Second Preliminary Consultation
MONTGOMERY COUNTY HISTORIC PRESERVATION COMMISSION
STAFF REPORT

Address:	38 Philadelphia Avenue, Takoma Park	Meeting Date:	10/23/2024
Resource:	Contributing Resource Takoma Park Historic District	Report Date:	10/16/2024
Applicant:	DTP RE Fund 3, LLC (Richard Vitullo, Architect)	Public Notice:	10/9/2024
Review:	Preliminary Consultation	Staff:	Dan Bruechert
Proposal:	Construction of a new second-story and two-story rear addition with basement

Figure 2: Proposed location for the second-story addition, identifying the area of the historic roof to be demolished.

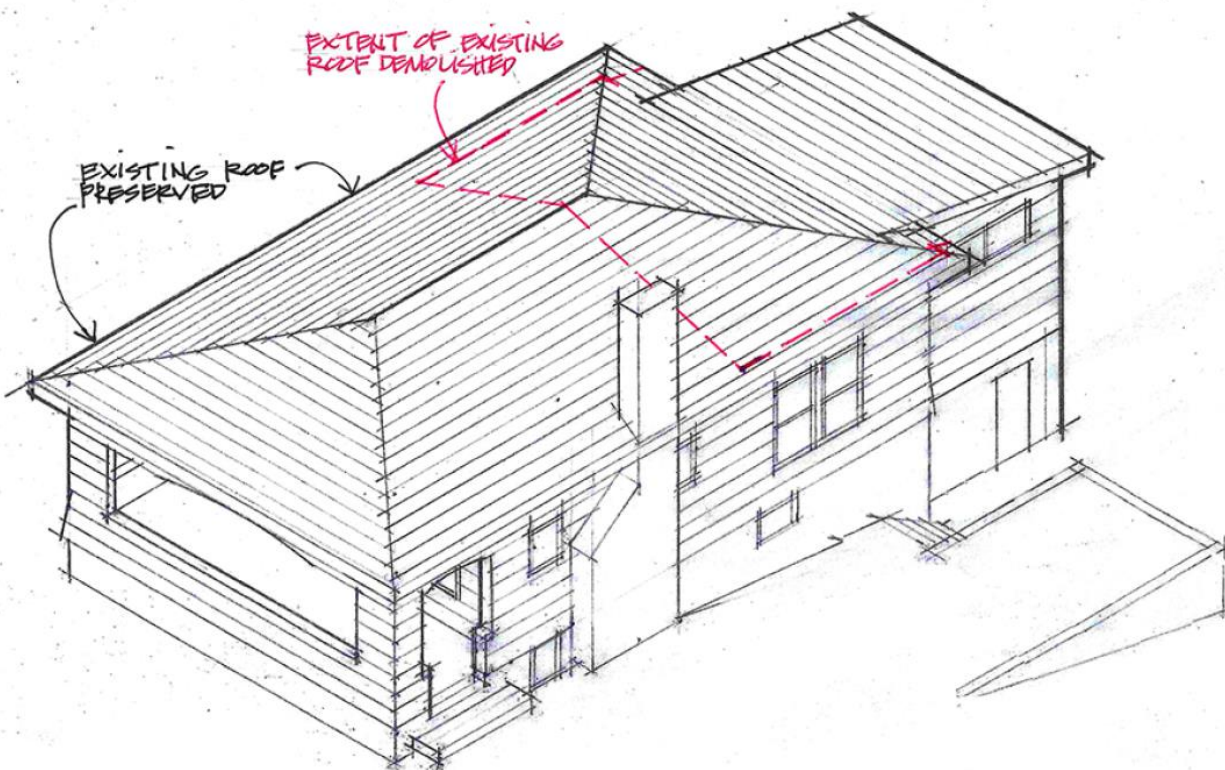
The applicant proposes to remove the rear section of the low-pitched hipped roof (4:12) and install a second story beginning at the third bay toward the rear. The proposal will preserve the front 23' 10" (twenty-three feet, ten inches) of the historic roof. Scheme A has a hipped roof with a ridge height of 23' 10" (twenty-three feet, ten inches); with a lower hipped roof for the rear addition (discussed below). Details for the treatment of the eaves was not provided in the drawings. Scheme B proposes a front gable roof with a ridge height of 26' 10" (twenty-six feet, ten inches) and includes a small fixed window under the gable. Roof shingles for the second-story addition will match the historic house. The second-story rear addition extends 6' 6" (six feet, six inches) to the rear of the historic rear wall plane and will preserve the rear corners and roof overhang.

Figure 3: Proposed scheme 'A' (left) and scheme 'B' (right).

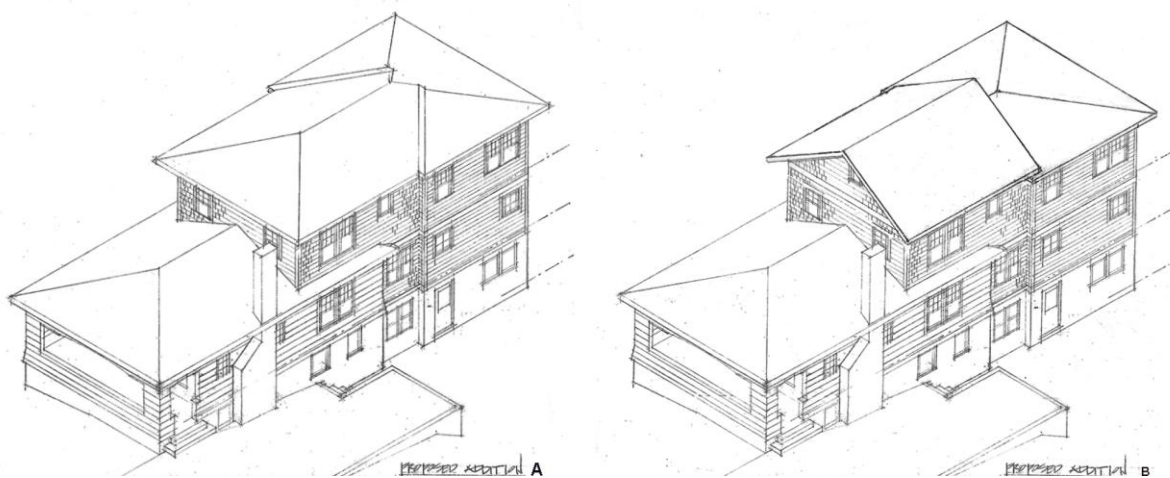
Staff finds the proposed scheme ‘B’ is too tall and massive, and overwhelms the historic construction. Staff finds this proposal is inappropriate for the historic resource.

Staff finds scheme ‘A’ is more compatible with the historic resource, as it is 8’ 6” (eight feet, six inches) taller than the existing hipped roof ridge. This proposal is approximately 2’ (two feet) taller than the proposal presented at the last preliminary consultation. However, that proposal altered the historic roof form and brought it to the front wall plane of the existing porch (see *Fig. 4*, below), whereas this scheme retains the historic hip for the front two-thirds of the house (exact measurements for this distance were not included in the submitted materials), Staff finds the currently proposed Scheme ‘A’ is more compatible with the character of the historic resource.
